Attachment 3
RA-18-0015

Attachment 3
Response to NRC Request for Additional Information
(MNS only)

APLA RAI-02 – Modeling Alternative Alignments

Table A-1a. Mean and Fractile Seismic Hazard Curves for PGA at McGuire

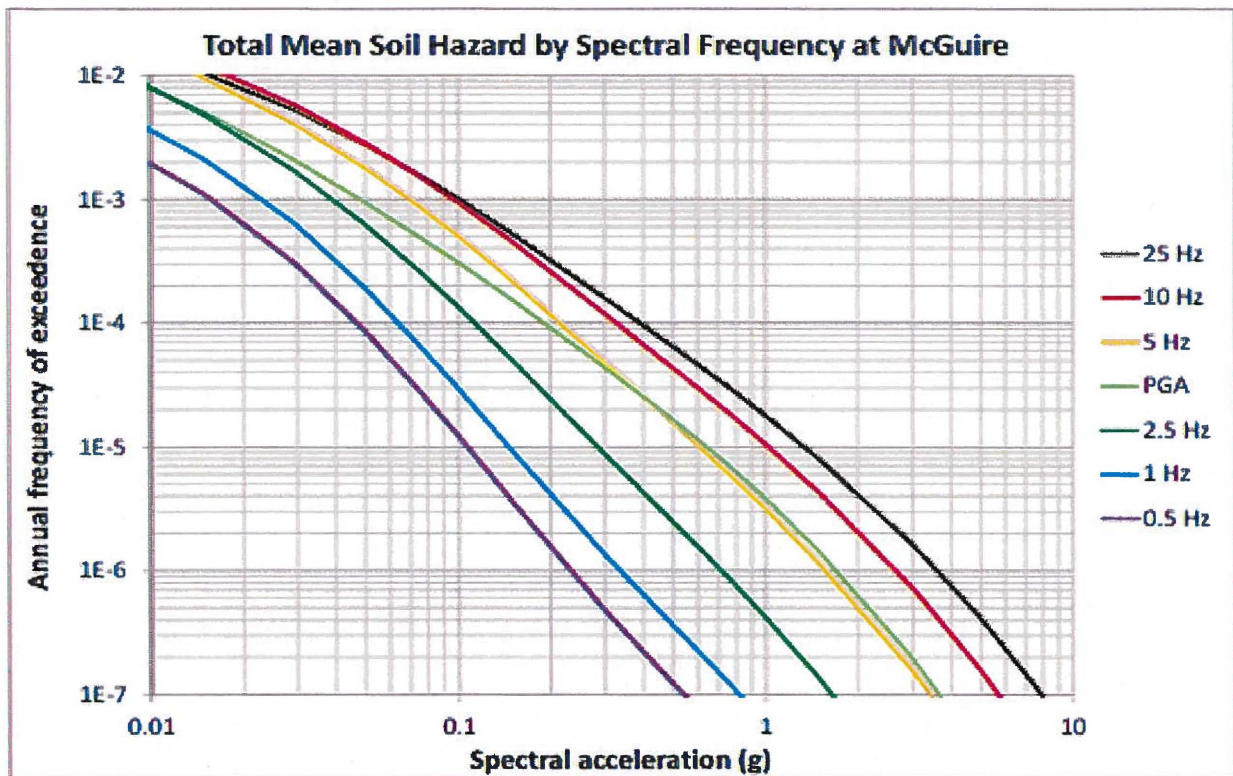
The delta seismic CDF and LERF was evaluated over the latest McGuire seismic hazard. Using Table A-1a of the McGuire seismic hazard report¹, the mean probability of exceedance at peak ground acceleration (pga) at various points along the hazard was obtained. (This is depicted both graphically and in tabular form:

The hazard was divided into six segments, or "bins", to provide an assessment over relatively uniform intervals. The bins selected are shown below (Note: the last bin encompasses all earthquakes greater than 1.0g).
